ADDENDUM 1

PROJECT NAME: APACHE CREEK LINEAR PARK LIGHTING UPGRADES

DATE: September 11, 2020

PROJECT NO: 29652000

SHEET:
ES1.1

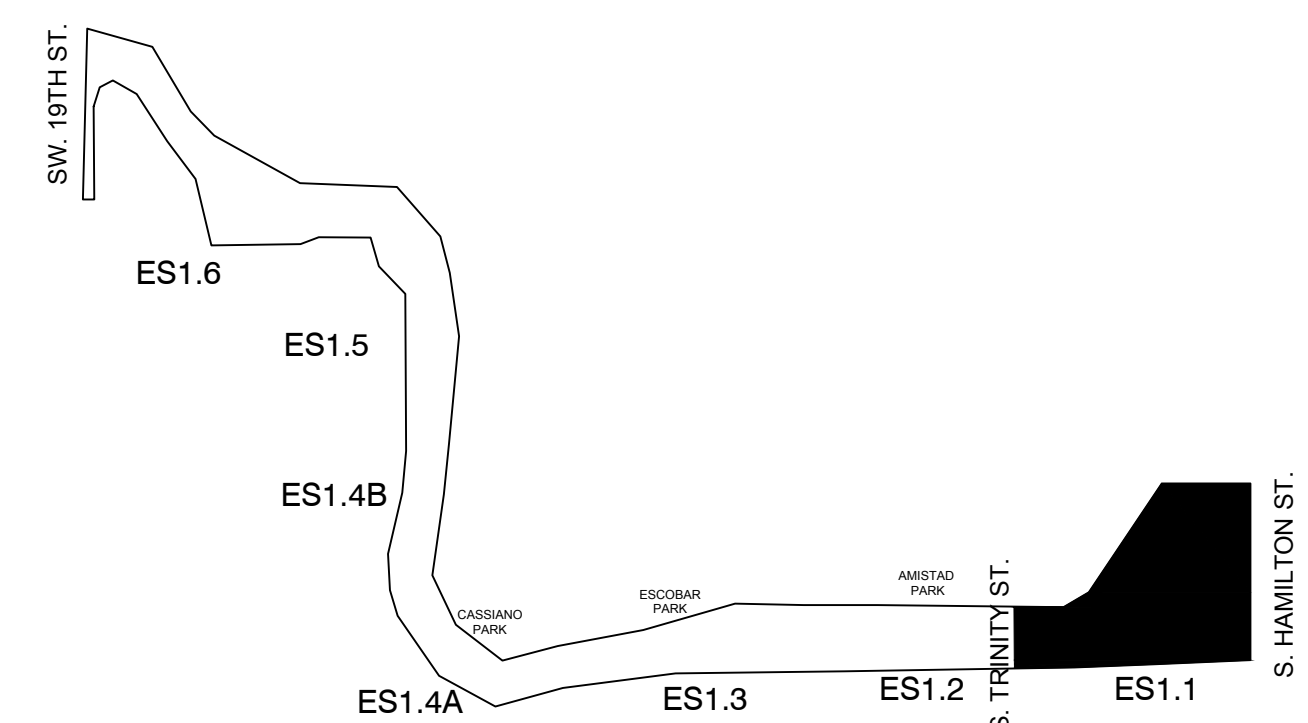
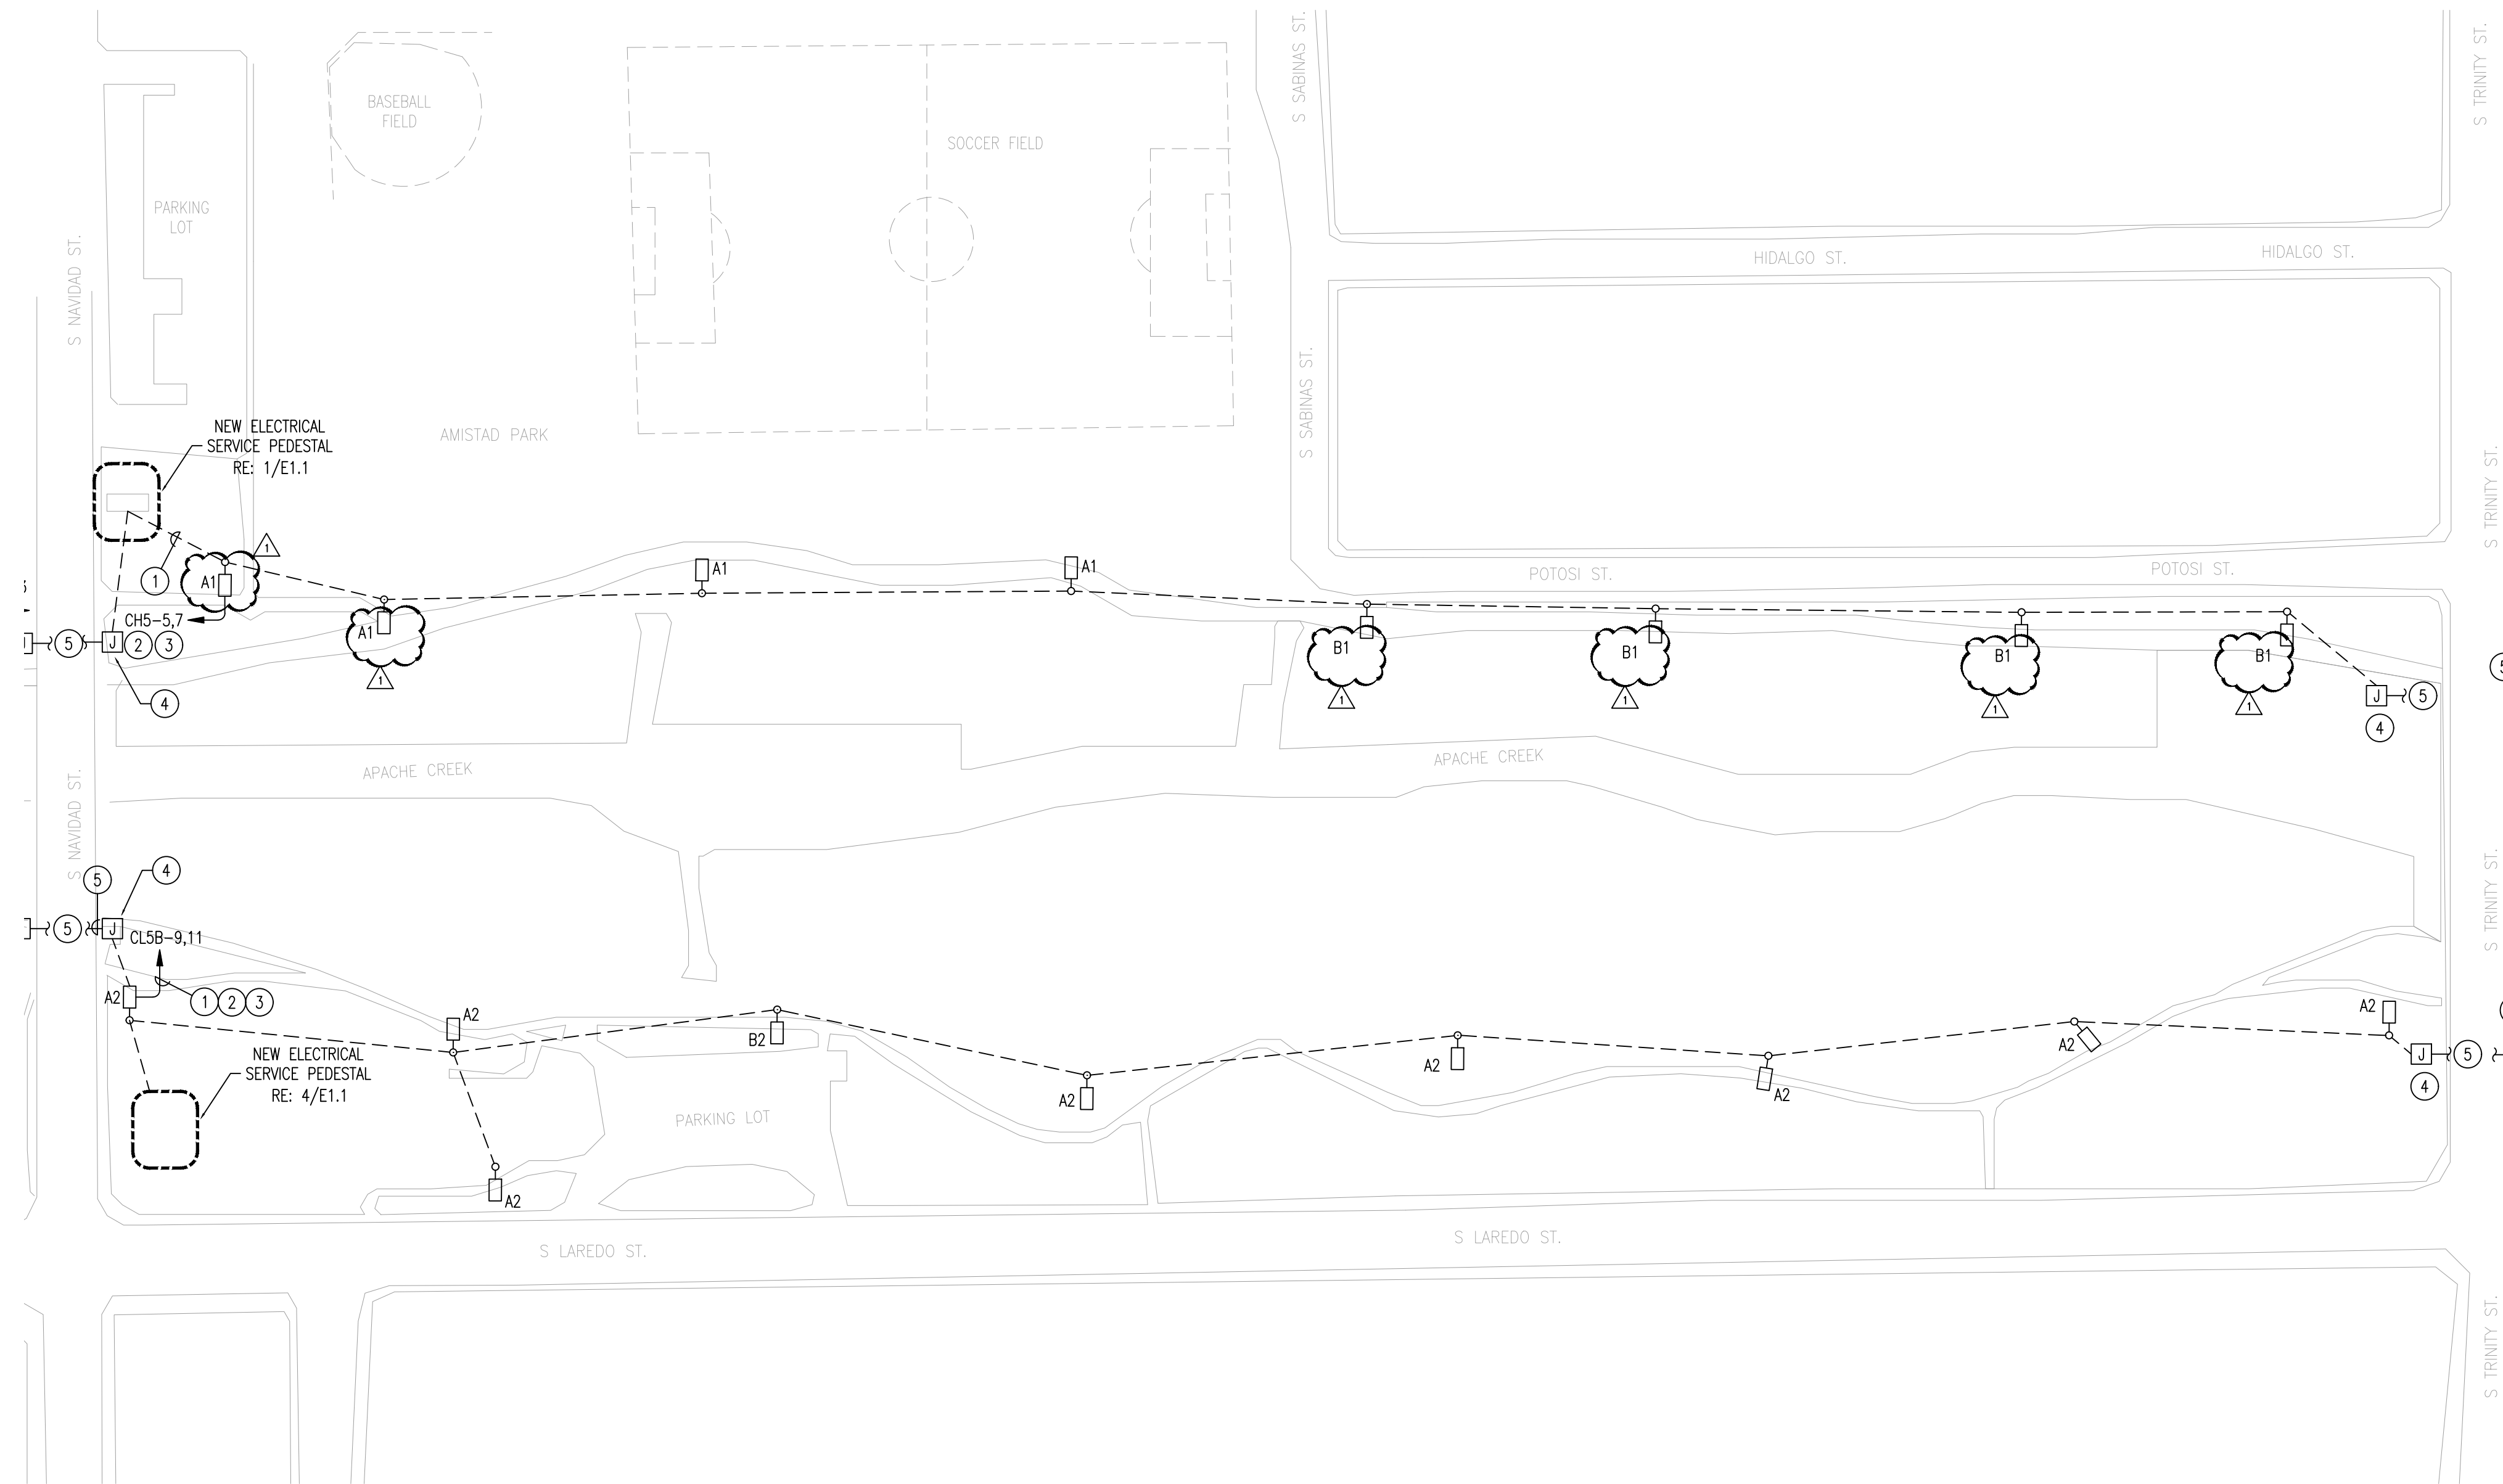
- viii. RE: Plan Sheet ES1.1:
 - a. Item 1: Revised key note 5.
 - b. Item 2: Added note to contractor regarding pole base location, as indicated.
- ix. RE: Plan Sheet ES1.2:

1. PROVIDE CONDUIT(S) FOR CIRCUITRY, AS INDICATED. COORDINATE ROUTING WITH ENGINEER(S) PRIOR TO TRENCHING TO AVOID CONFLICTS WITH ANY FIELD ITEMS.
2. PROVIDE (1) 1" CONDUIT FOR LIGHTING CIRCUIT WITH (2)#8 AWG CU, AND (1)#8 GND.
3. ROUTE CIRCUIT THRU LIGHTING CONTACTOR/TIMELOCK ASSEMBLY.
4. PROVIDE IN-GROUND PULL BOX. COORDINATE LOCATION WITH ENGINEER(S) PRIOR TO ROUGH-IN TO AVOID ANY CONFLICTS WITH ANY FIELD ITEMS.
5. PROVIDE NEW (1) 1" CONDUIT ACROSS BRIDGE. ROUTE CONDUIT UNDERNEATH AND ACROSS BRIDGE.

ES1.2

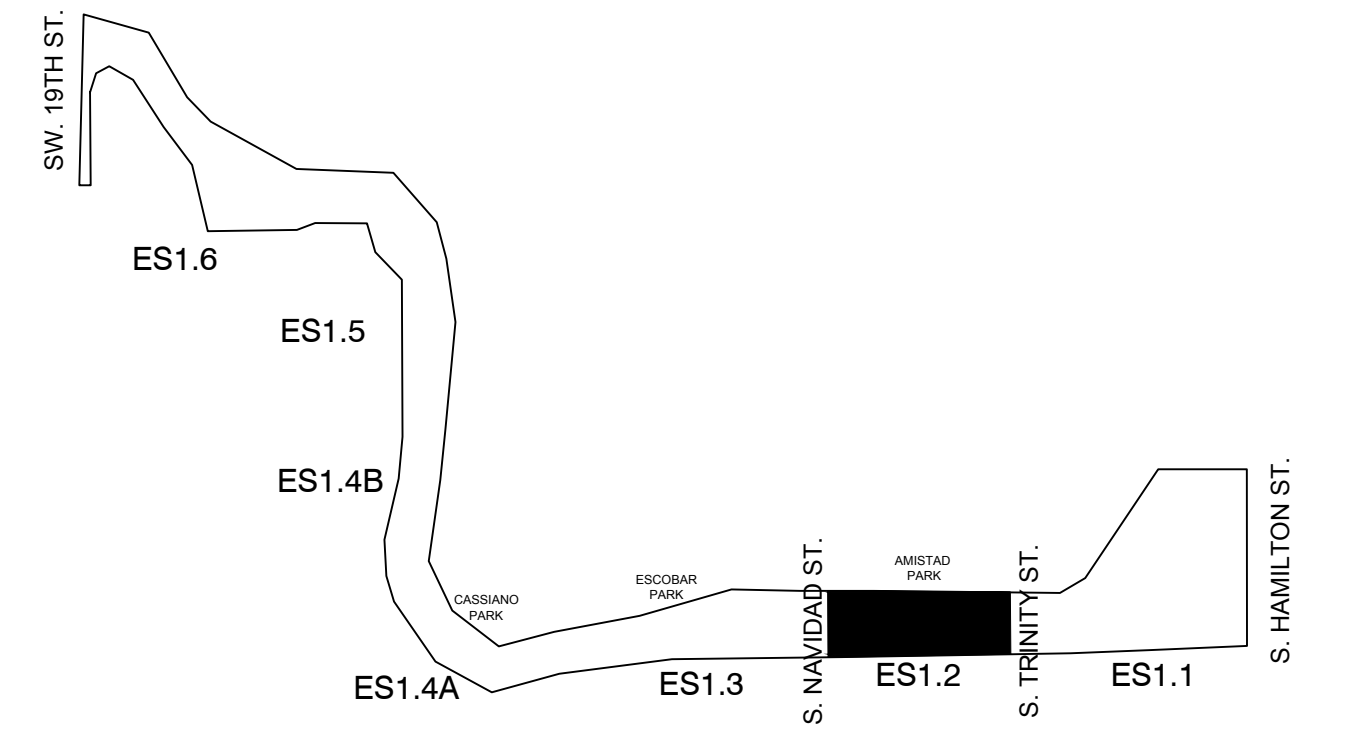
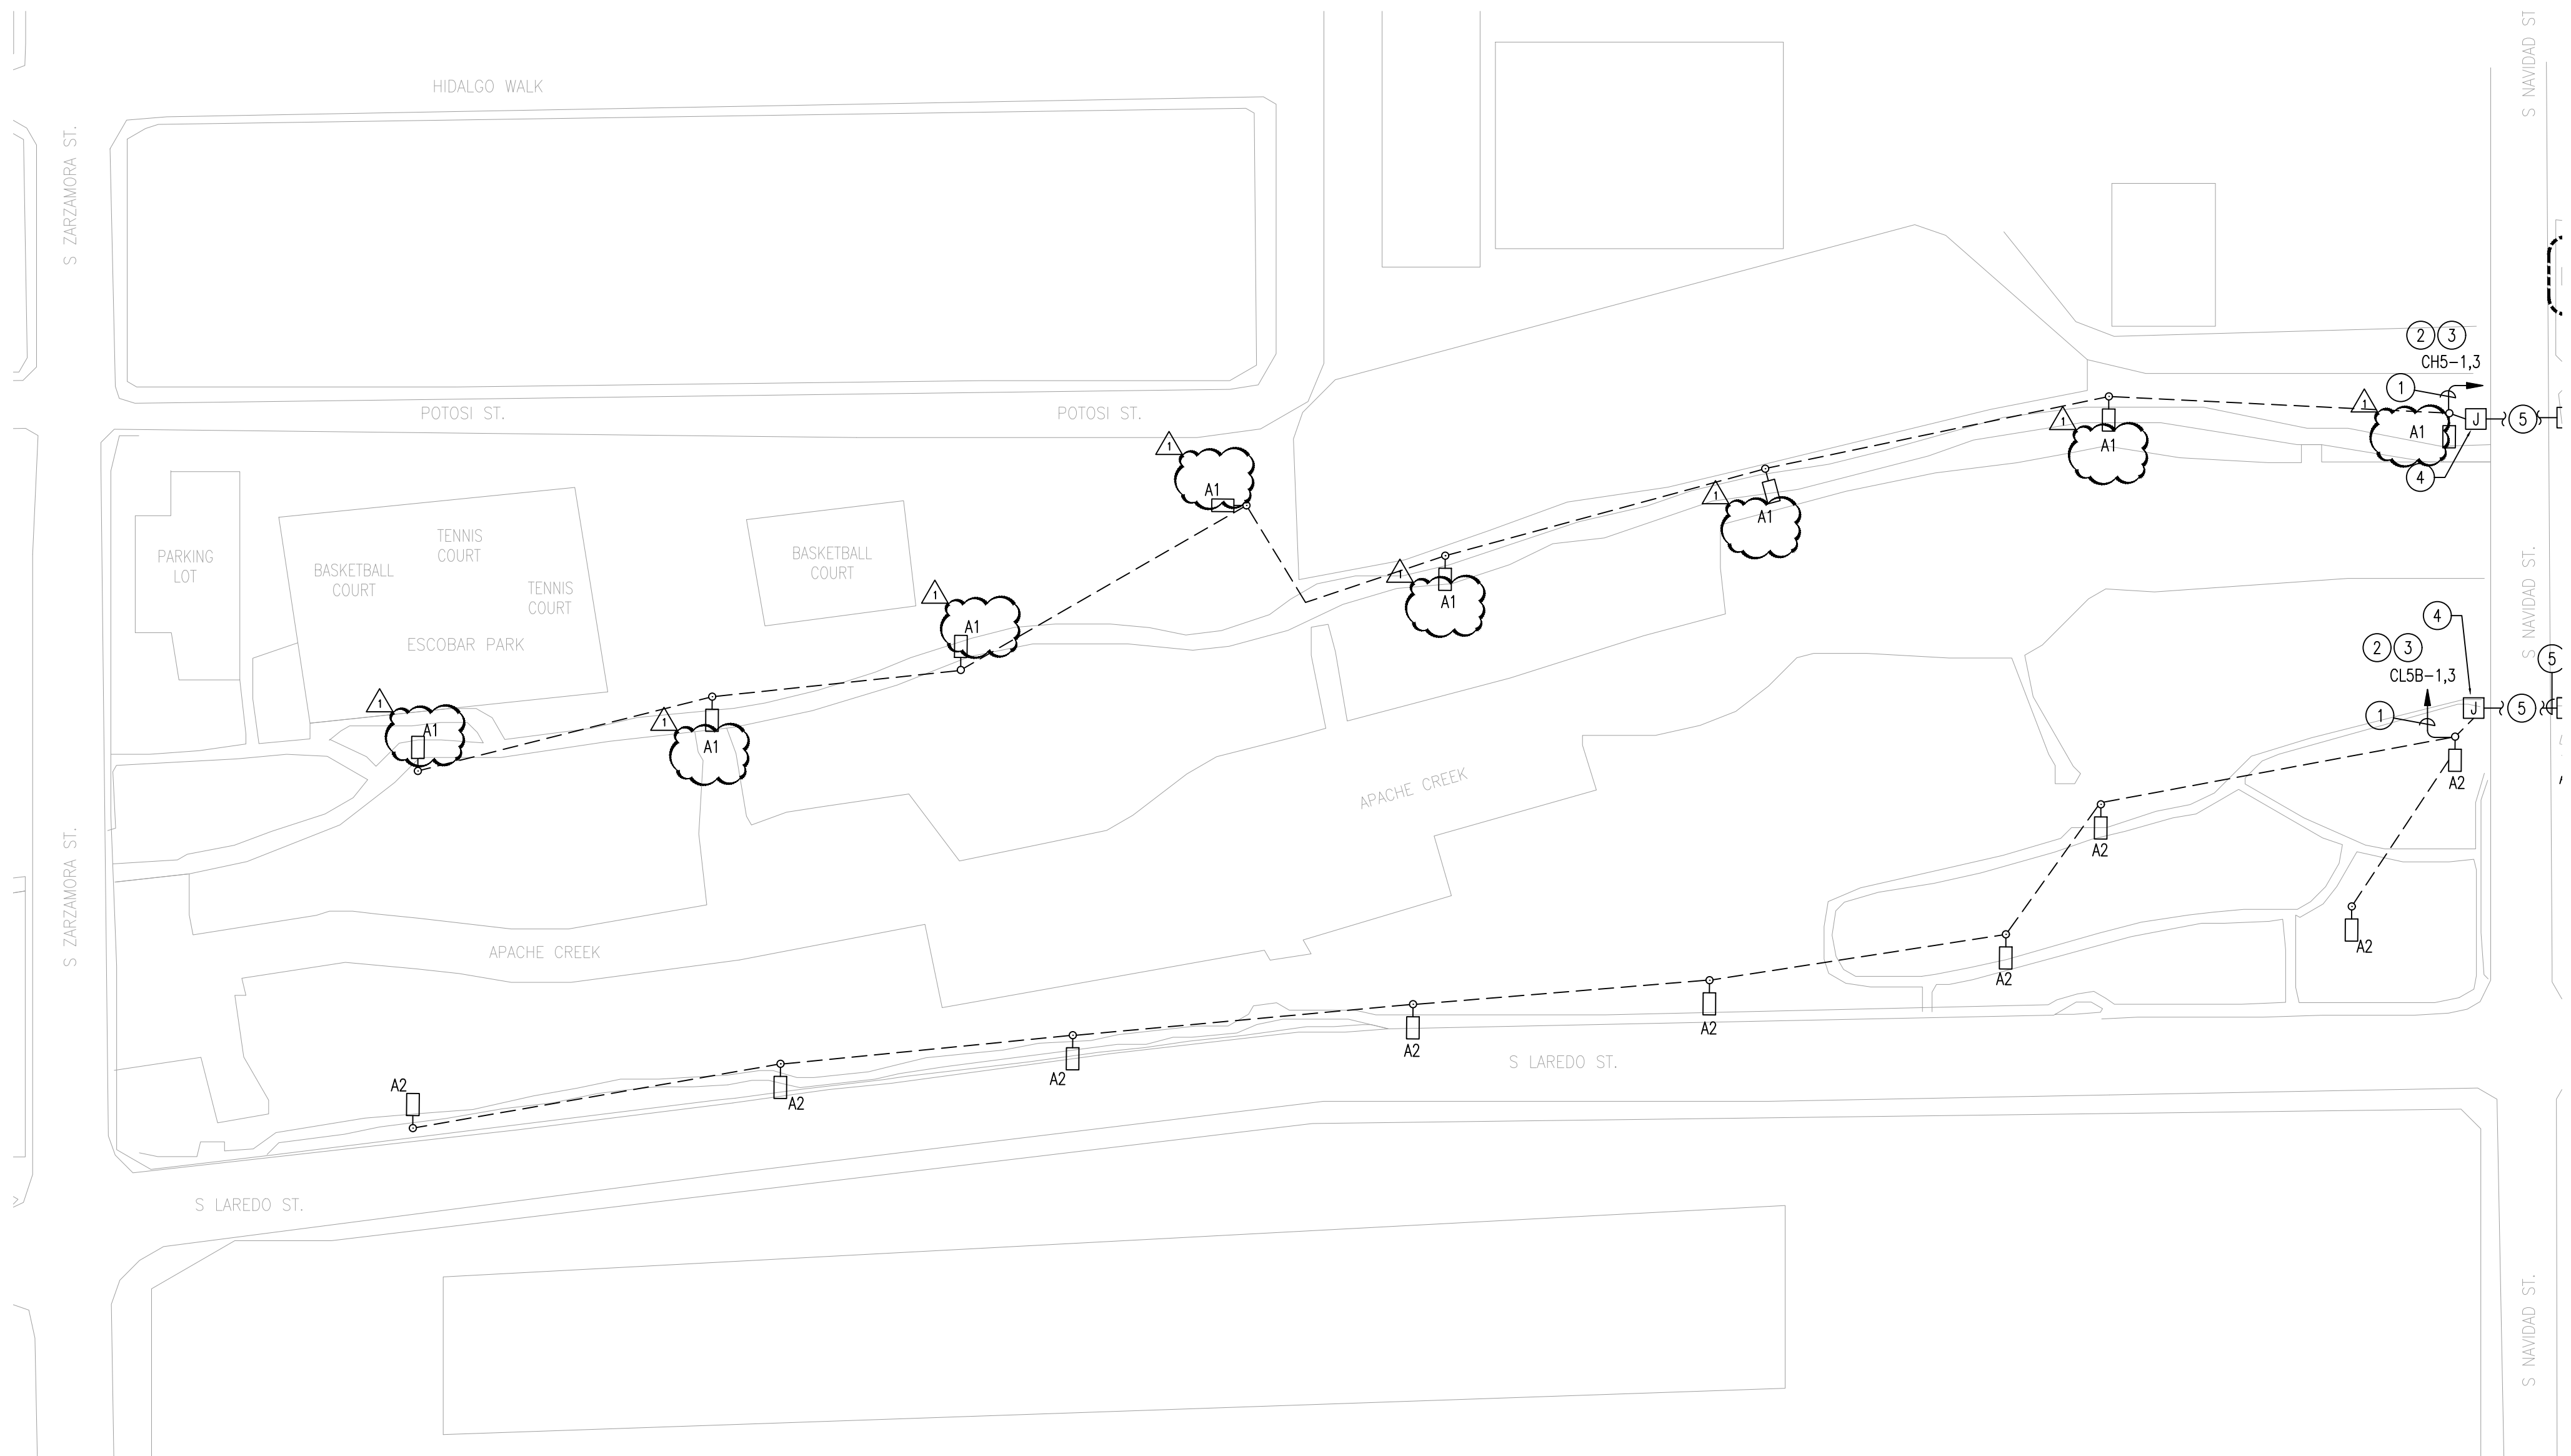
- a. Item 1: Revised key note 5.
 - b. Item 2: Revised fixture type, as indicated.
 - c. Item 3: Added note to contractor regarding pole base location, as indicated.

2. Fixture types A and B appear on sheets ES1.2 and ES1.3 but not on light fixture schedule. Can you please clarify?
 - Answer: See addendum 01 for updated drawings.

1. PROVIDE CONDUIT(S) FOR CIRCUITRY, AS INDICATED. COORDINATE ROUTING WITH ENGINEER(S) PRIOR TO TRENCHING TO AVOID CONFLICTS WITH ANY FIELD ITEMS.
2. PROVIDE (1) 1" CONDUIT FOR LIGHTING CIRCUIT WITH (2) #8 AWG CU, AND (1) #8 GND.
3. ROUTE CIRCUIT THRU LIGHTING CONTACTOR/TIMECLOCK ASSEMBLY.
4. PROVIDE IN-GROUND PULL BOX, COORDINATE LOCATION WITH ENGINEER(S) PRIOR TO TRENCHING TO AVOID ANY CONFLICTS WITH ANY FIELD ITEMS.
5. PROVIDE NEW (1) 1" CONDUIT ACROSS BRIDGE. ROUTE CONDUIT UNDERNEATH AND ACROSS BRIDGE.
